CLEARFIELD CITY PLANNING COMMISSION MEETING AGENDA

STAFF REPORT

SUBJECT: Discussion and Possible Action on **SP 2023-0201**, a site plan approval request by Jarod Hall with Divelept Design for a three-story mixed use building at the subject property. **Location:** 246 East 200 South (TIN: 12-003-0042). **Parcel Area:** 0.33 Acres. **Zone:** U-C (Urban Core Commerce). **(Administrative Action).**

Project Information	
Project Name	246 UHB Mixed-Use
Site Location	246 East 200 South
Tax ID Number	12-003-0042
Applicant	Jarod Hall, Divelept Design
Owner	True Real Estate Holdings, LLC
Proposed Actions	Site Plan Review Approval
Current Zoning	U-C (Urban Core Commerce)
Site Area	0.33 Acres

45 EAST ELEVATION REVIEW
1/8" = 1'-0"

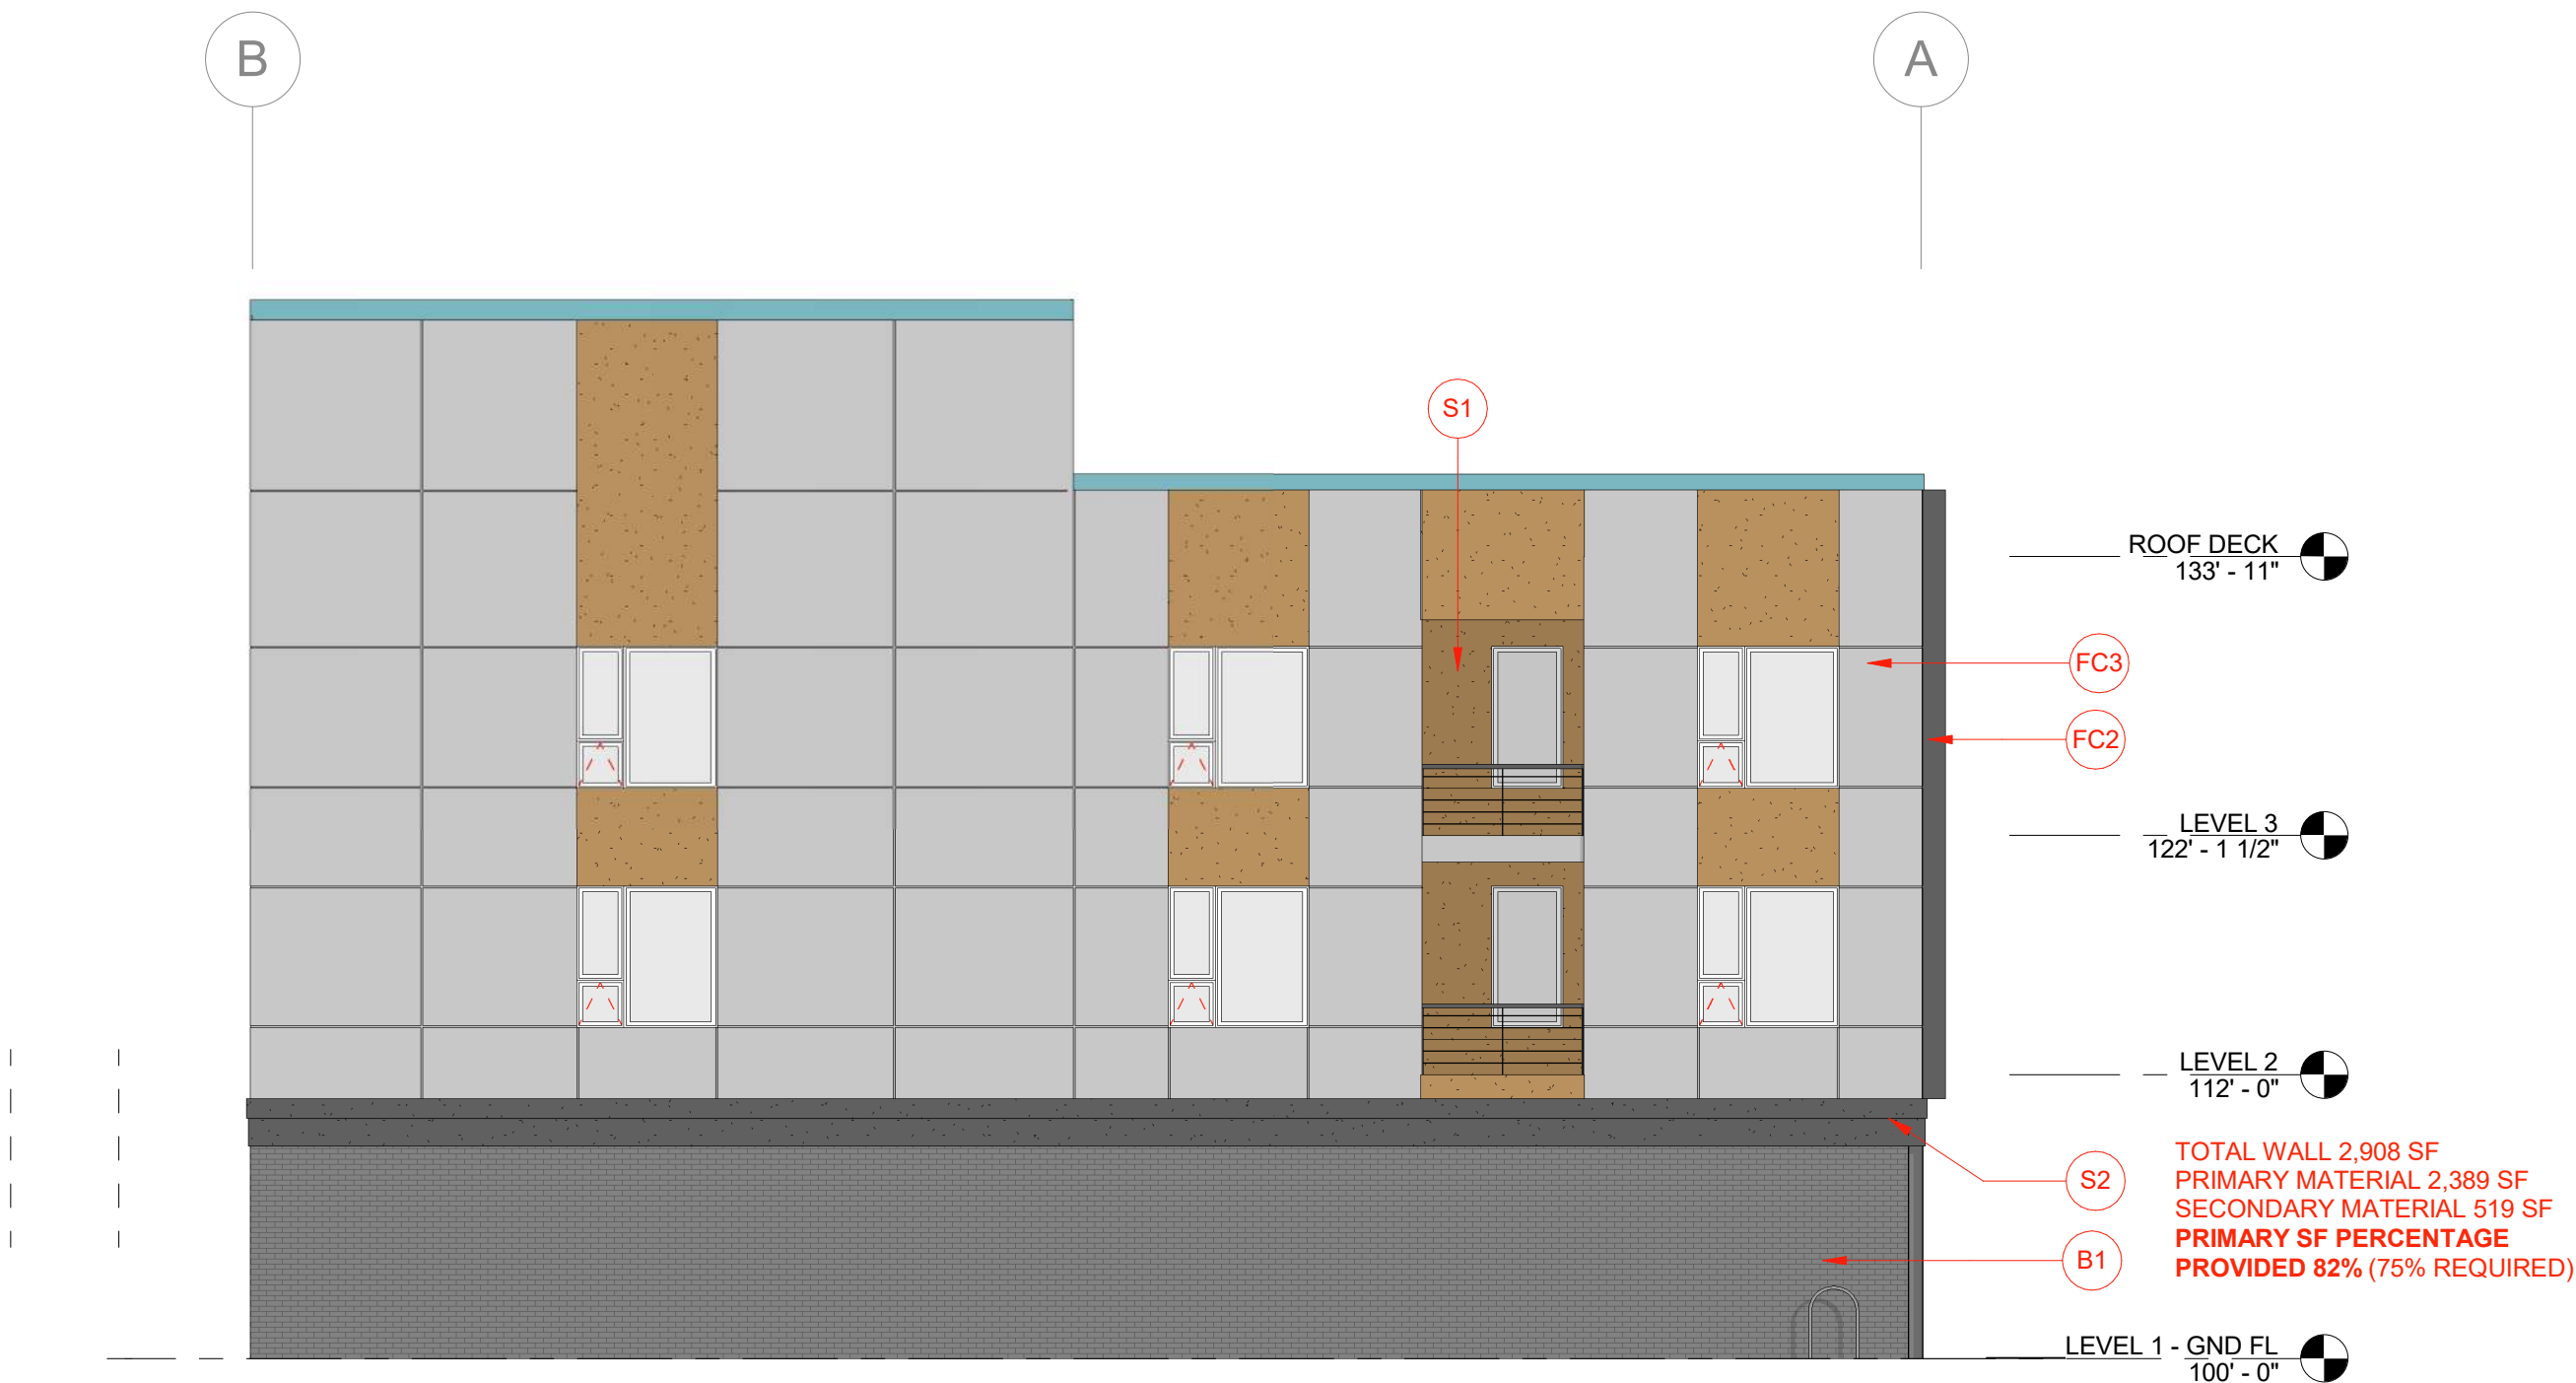
<i>Horizontal Façade Divisions:</i> Required within 3' of the ground story and at the top of the highest story.	Non-Compliance with FBC <u>Staff Note:</u> The change in materials from the ground floor to the upper floors complies with this standard. There is no façade division at the top of the highest story. This can be accomplished with a cornice, belt course, molding, string course, or other continuous horizontal ornamentation a minimum of one and a half inches in depth.
---	--

Standard:	Staff Analysis:
<i>Permitted Roof Type:</i> Parapet or Flat	Non-Compliance with FBC <u>Staff Note:</u> The project provides a parapet roof type with an indistinct height. It appears to be a 3.5' parapet in some areas, but more detail is needed to show that the parapet height around the entire perimeter is within the allowed two to six feet and high enough to screen the roof and any roof appurtenances from view. Additionally, an expression line shall define the parapet from the upper stories of the building on all sides and shall also define the cap (FBC 6.12 Roof Types).

- 4) The plans shall be revised to include a horizontal façade division for the top of the highest story of the street facing façade that meets the façade articulation standards found in Chapter 6 of the Clearfield City Downtown Form Based Code. This can be accomplished with the horizontal expression line referenced in Condition #4.

- 5) The plans shall be revised to include a horizontal expression line to define the parapet from the upper stories of the building on all sides.
- 6) The plans shall be revised to include a note indicating that commercial quality doors, windows, and hardware will be used for the building.

LANDSCAPE
SITE PLAN

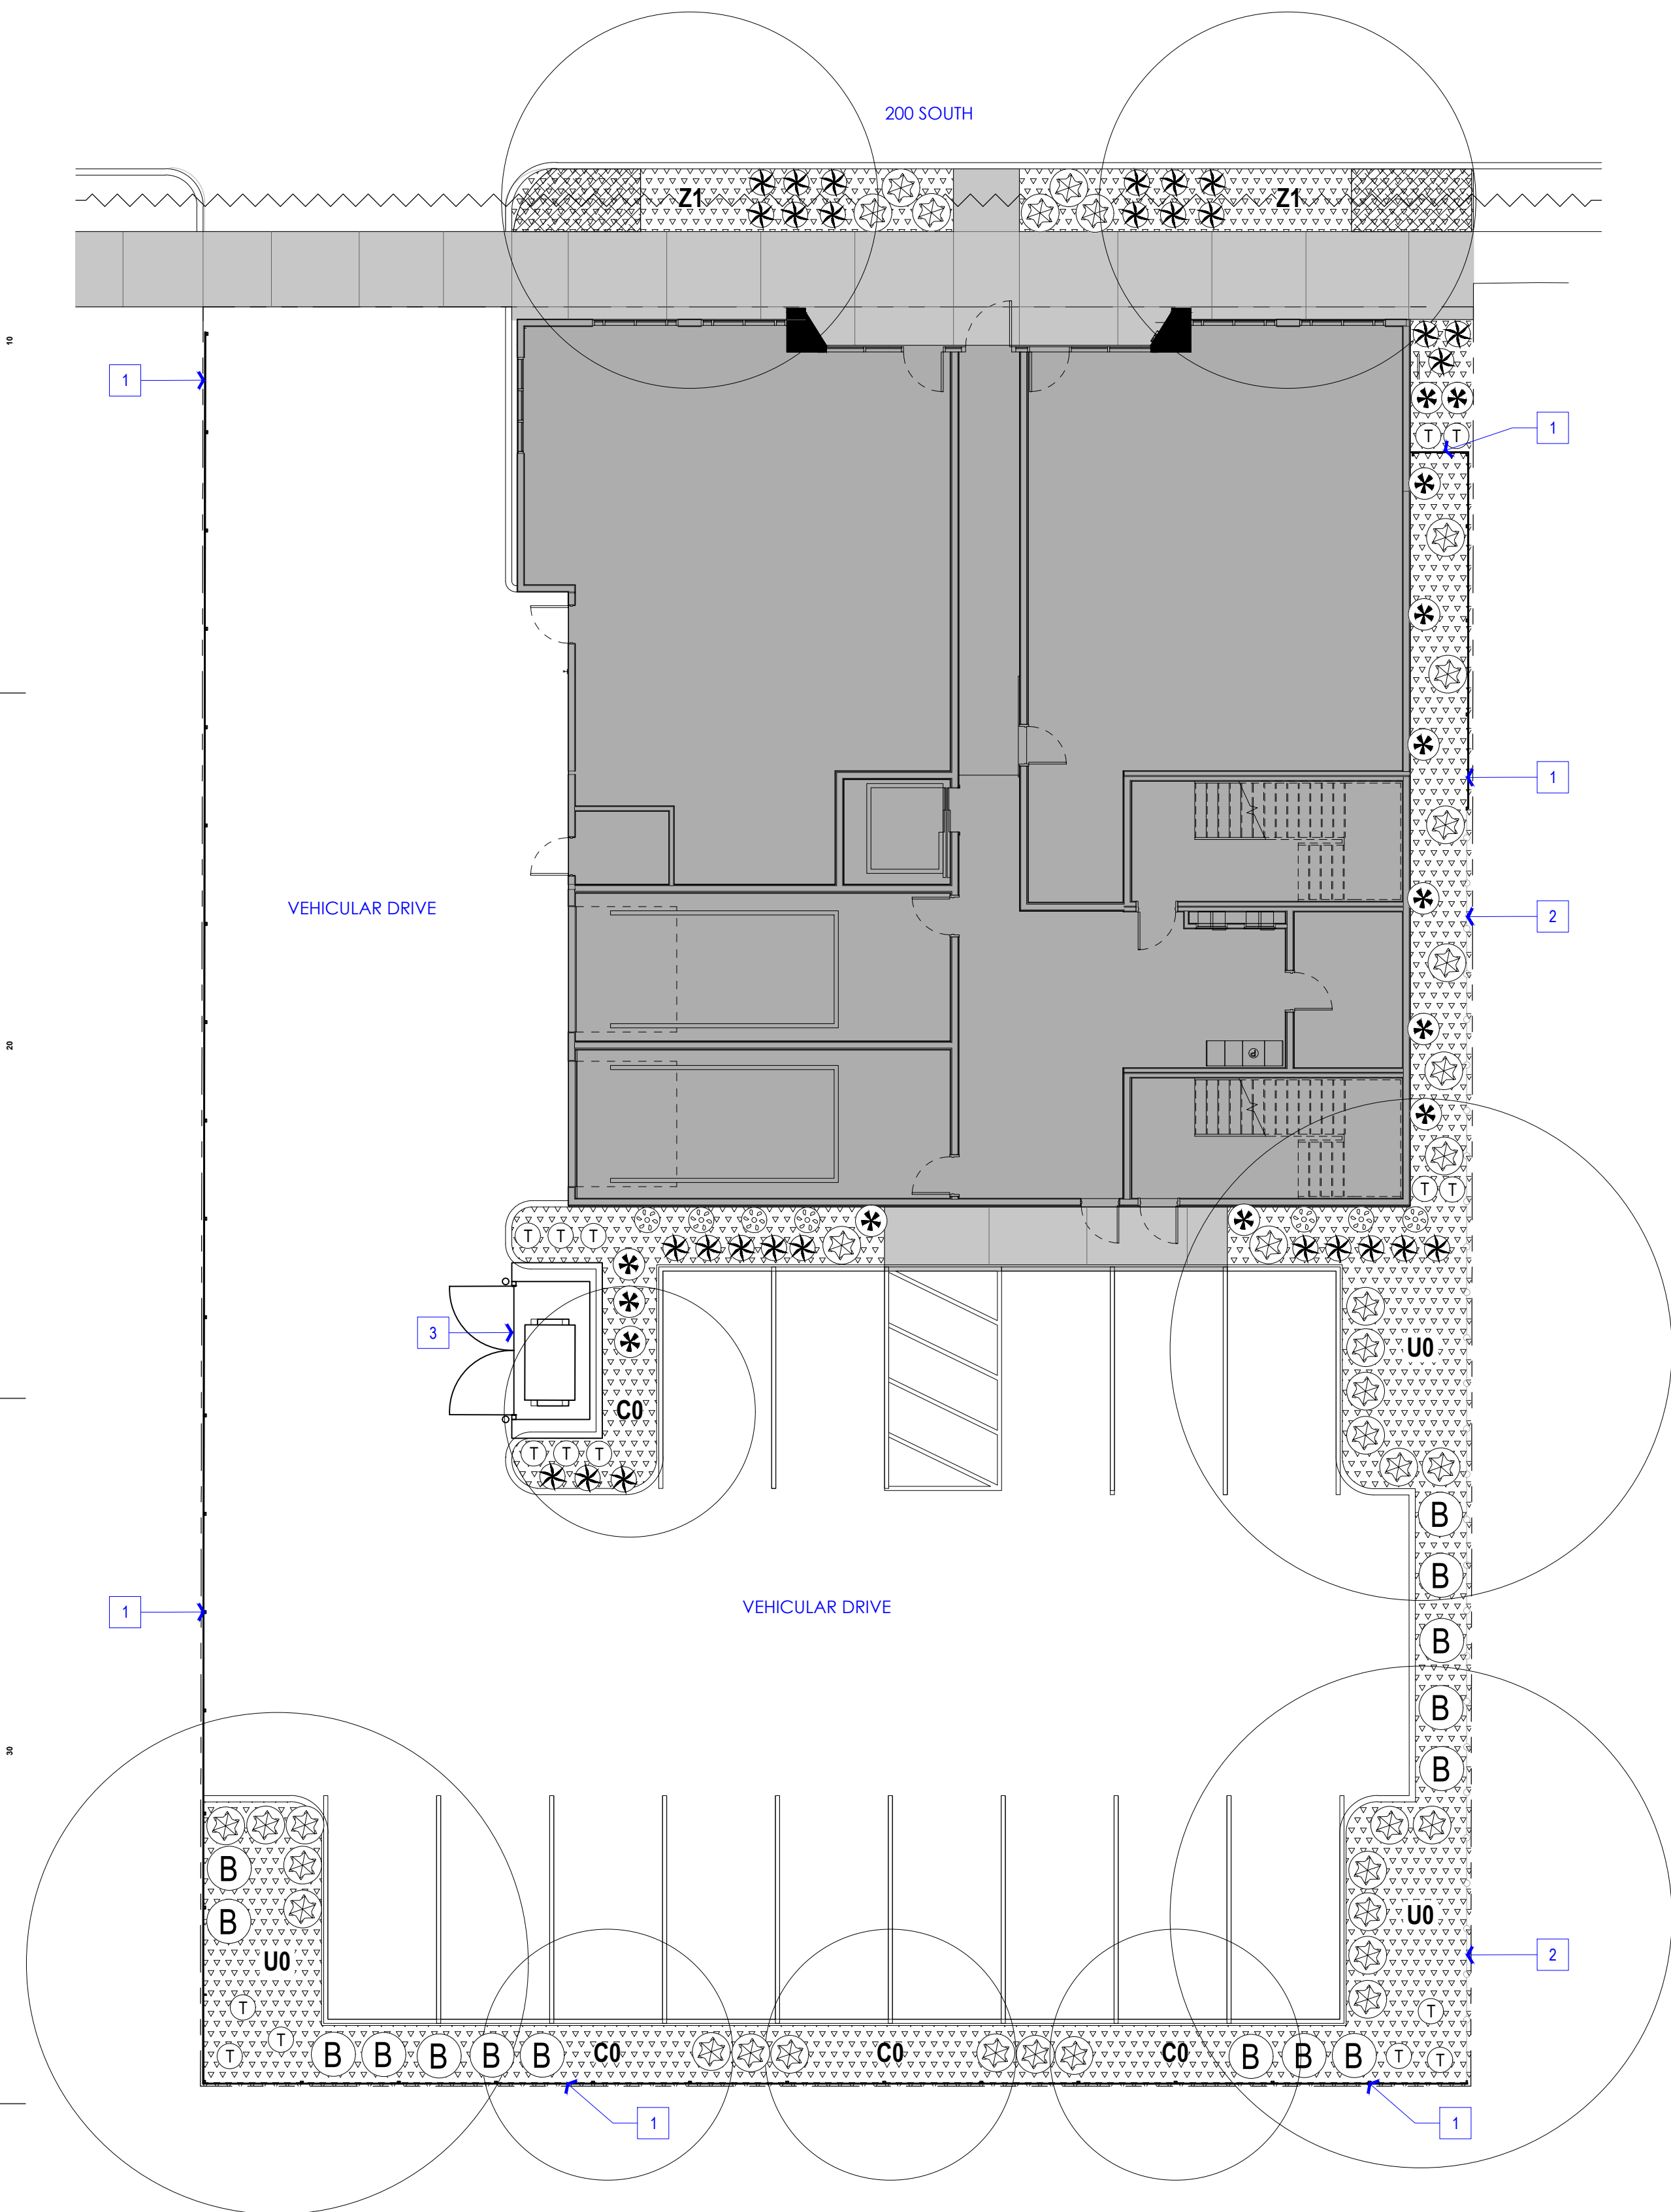
covers to meet this standard. The install size of the deciduous shrubs needs to be increased to five (5) gallons.
Plant material shall be placed around the perimeter of the building footprint in a 4-foot minimum planting strip with the exception of entrances, utilities, and where required setbacks are less than 4 feet.	Complies with FBC
The maximum amount of landscape area that may be turf grass is 15%.	Complies with FBC <u>Staff Note:</u> The project does not utilize any turf grass.
Irrigation Systems	Non-Compliance with FBC <u>Staff Note:</u> The applicant needs to submit an irrigation plan to accompany the landscape plan so that staff can verify compliance with the Irrigation Systems standards found in Chapter 7 of the FBC.

<i>Fencing</i>	Non-Compliance with FBC Staff Note: The plans show a new fence to be installed along the rear and west property lines. The plans will need to be revised to show fence heights. Fences shall be opaque and constructed of materials that complement the building. White vinyl only and chain link with slats are not allowed.

- 7) The landscape plans shall be revised to include the following:
 - a. The install size of the deciduous shrubs needs to be increased to five (5) gallons.

- b. An irrigation plan that meets the 'Irrigation System' requirements found in Chapter 7 of the FBC needs to accompany the landscape plan.
 - c. A note and detail need to be added to the plans showing the structural soil or urban root treatment for the five-foot (5') wide park strip, and the parking lot buffer areas that are less than seven feet (7') wide.

- 11) The plans shall be revised to show fence heights. Fences shall be opaque and constructed of materials that complement the building. White Vinyl only and chain link with slats are not allowed.

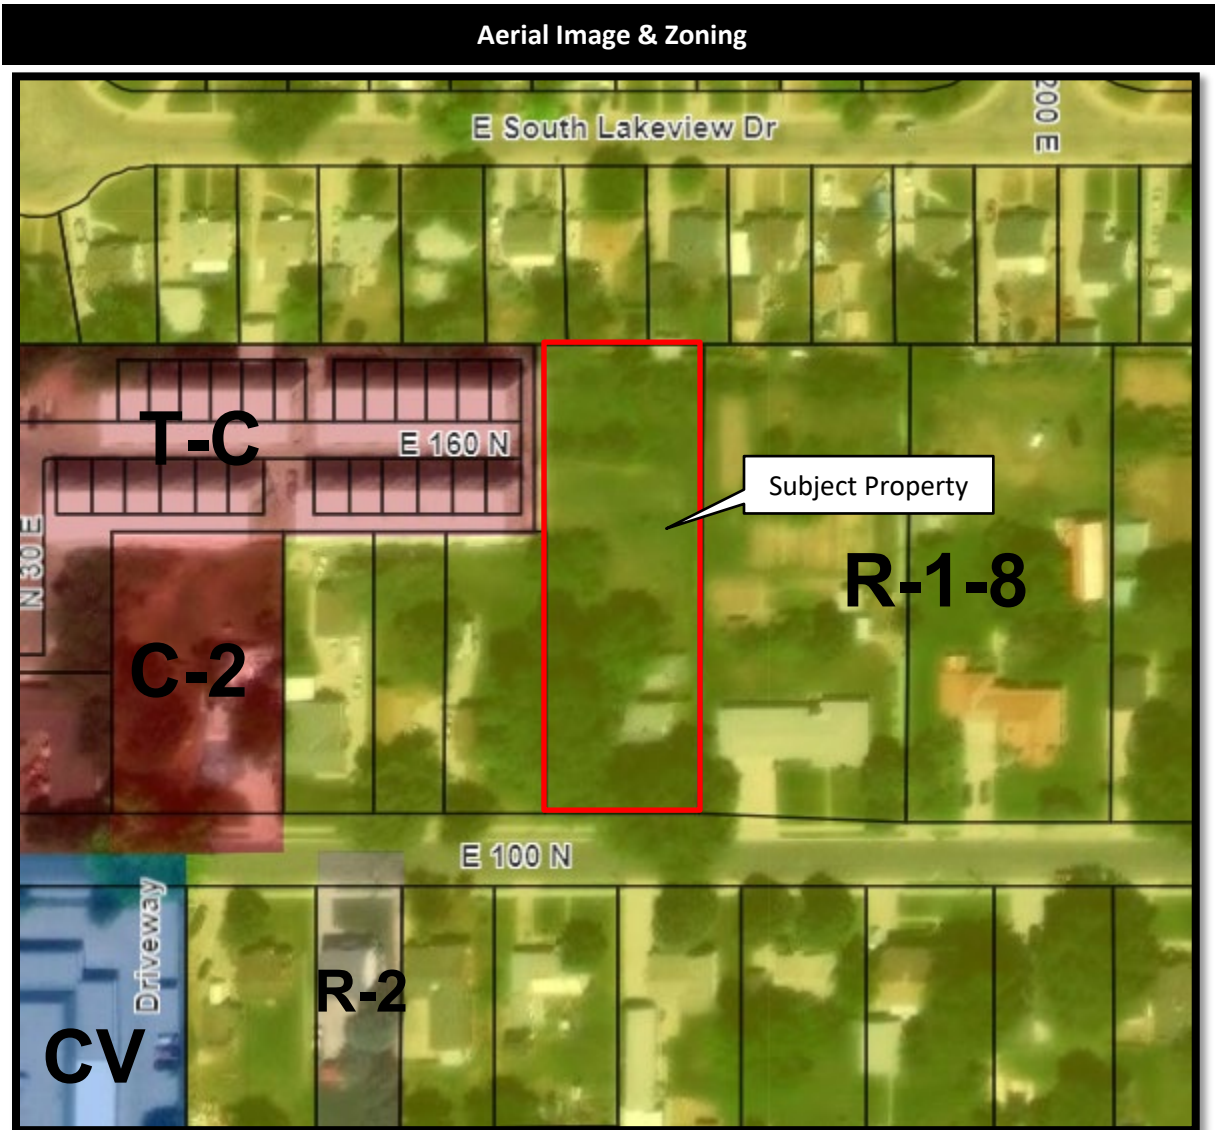
The subdivision plat will need to be revised to provide a cross access easement for the two lots which will also include a fire turnaround. The purpose behind the cross-access easement is to ensure full access for emergency vehicles, especially fire trucks, and access for both properties within one shared driveway. Without this shared access easement, each lot would be required to provide a fire truck turnaround. The cross-access easement will need to state that there is shared access between Lots 2 &

- 1) A reciprocal cross-access easement shall be provided on Lots 2 & 3 to provide sufficient emergency response access and access to the two properties.

- 4) Four feet (4') of landscaping shall be provided on the west and east sides of the shared driveway to accommodate storm water runoff and provide buffering from the adjacent properties.
